Memorandum

Village of Saranac Lake

95 Van Buren St., Saranac Lake, NY 12983

WR# 31145784

VILLAGE OF SARANAC LAKE MUNICIPAL GARAGE SERVICE REQUEST # 31145784

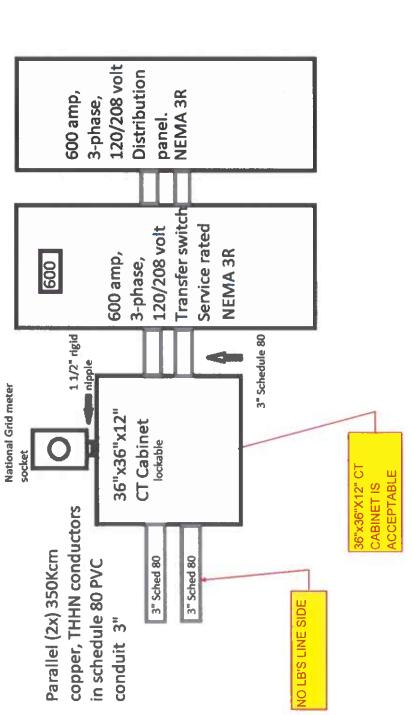
CT CABINET REQUIREMENTS
-36"x36"X12" CT CABINET IS
ACCEPTABLE
-ENTER/EXIT SIDES OF CT CAB
-SELF CONTAINED METER
SUPPLIED BY M&T DEPARTMENT,
-CAB MUST BE LOCKABLE
-CUSTOMER MUST INSTALL 1-1/2"
RIGID THREADED GALVANIZED
STEEL CONDUIT FROM CT CAB TO
SELF CONTAINED METER.
-NO LB'S LINE SIDE OF CAB
